Belt tensioner

febi no. 26775

ref. no. 611 200 04 70

for
Mercedes Benz CDi engines

febi no. 26775
ref. no. 611 200 04 70

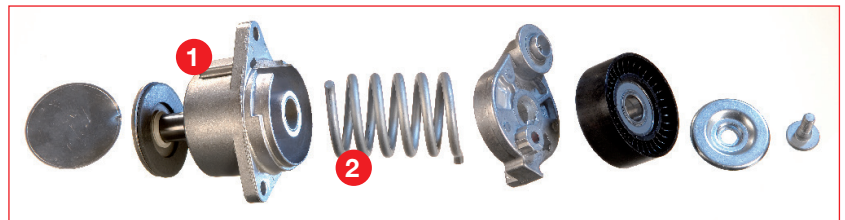
The noise is generated because the spring is too long and makes direct contact with the base of the housing (1). Only the spring's torsional characteristics are important for this application (2), (6).

The noise is caused when the spring touches the cast-in hollow pin (3) and the base of the housing (4).

febi supplies the belt tensioner febi no. 26775 (ref. no. 646 200 02 70) for the free aftermarket. A highly wear-resistant plastic bushing (5) distance the spring from the base of the housing and prevents metal-to-metal contact where the spring is located. Since only the springs's torsional characteristics are important the height has been reduced (6). The spring makes contact with the plastic bushing (7) and is therefore prevented from touching the base of the housing. No noise can therefore occur. In the new version (8), a steel pin has been cast in the base of the housing in order to center the spring.
